Job Number: 5645

Meadowbank Education and Employment Precinct Schools Project
Response to Agency Submissions

enstruct has reviewed the authority submissions regarding the SSD-9343 Meadowbank Education and Employment Precinct Schools Project.

enstruct		
Status	FOR INFORMATION	
Job Title	MEADOWBANK SCHOOL	
Drawing Title	SECTION	
Scale	1:250 @ A3	
Drawn	JF	Date 24/01/2020
Job No.	5645	Checked TH
	Drawing No. SK-C-001	Rev 001

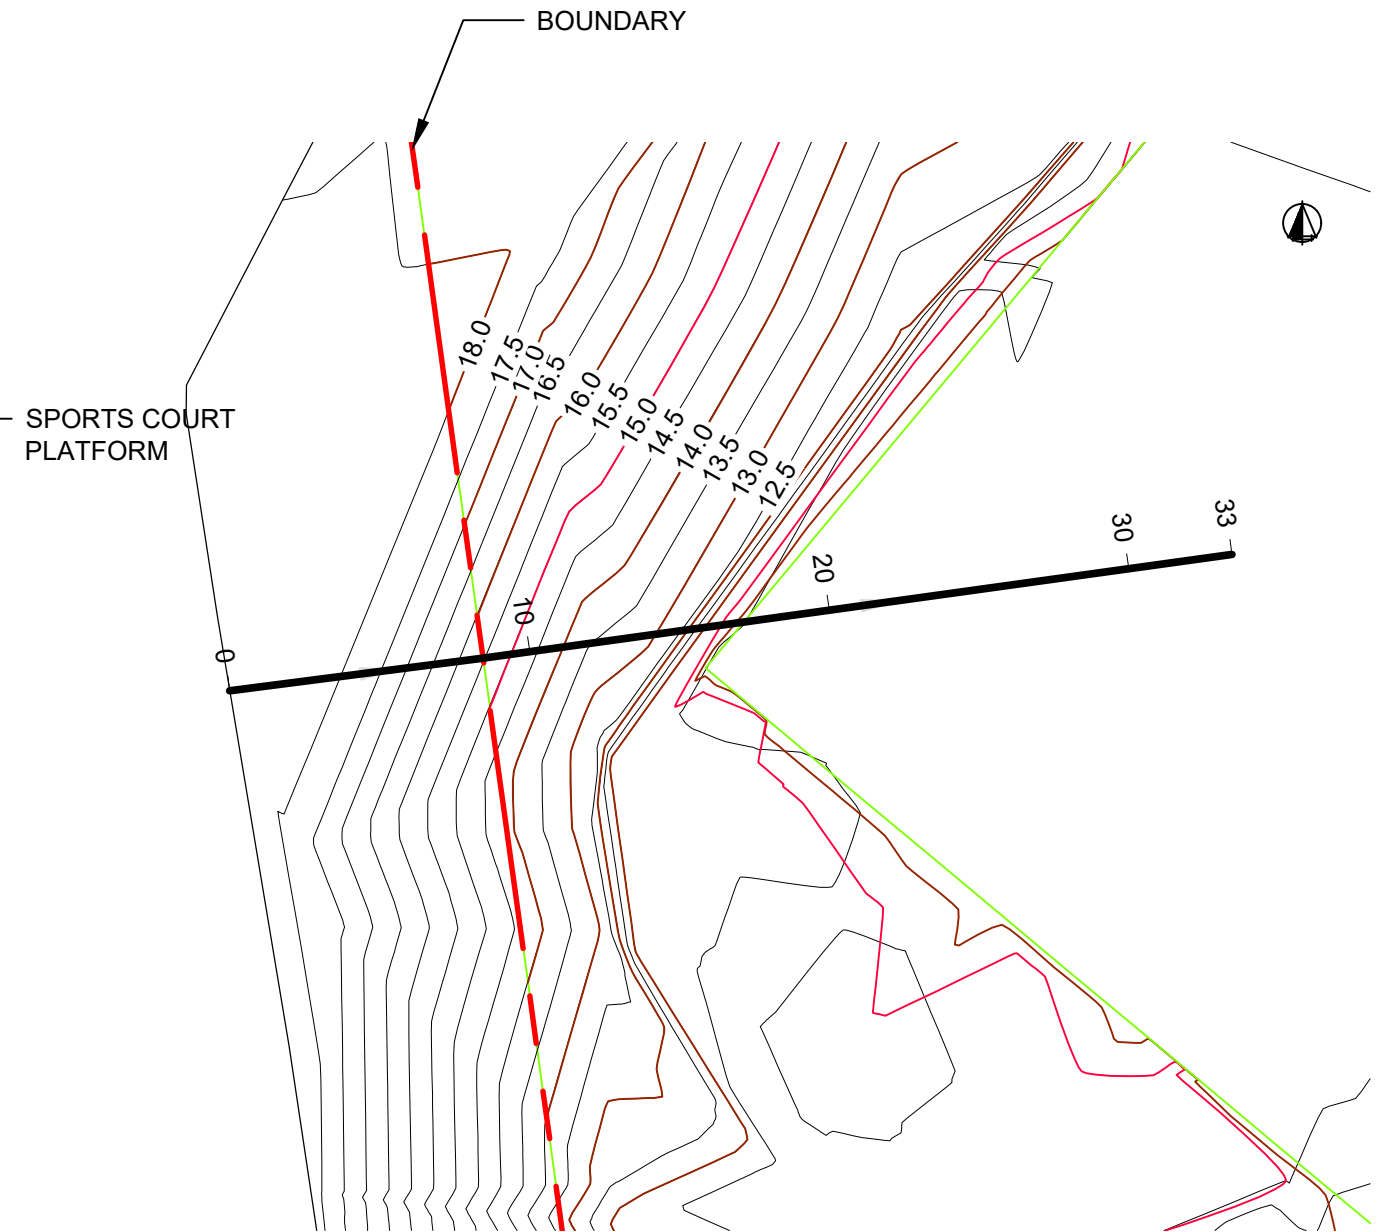
5.	Prior to the commencement of works, the Applicant shall provide certification from a qualified Geotechnical and Structural Engineers stating that the proposed works are to have no negative impact on the embankment, rail corridor and associated rail infrastructure. The provision of a cut and fill plan for all land within 25m of the rail corridor shall be provided as a minimum with the certification. If deemed by Sydney Trains that the works will or potentially have a negative impact, the Applicant shall provide the requested engineering documentation as advised by Sydney Trains for their endorsement.

Response: Attached to this letter is a section showing the excavation within 25m of the rail corridor. The excavation is less than 2m.
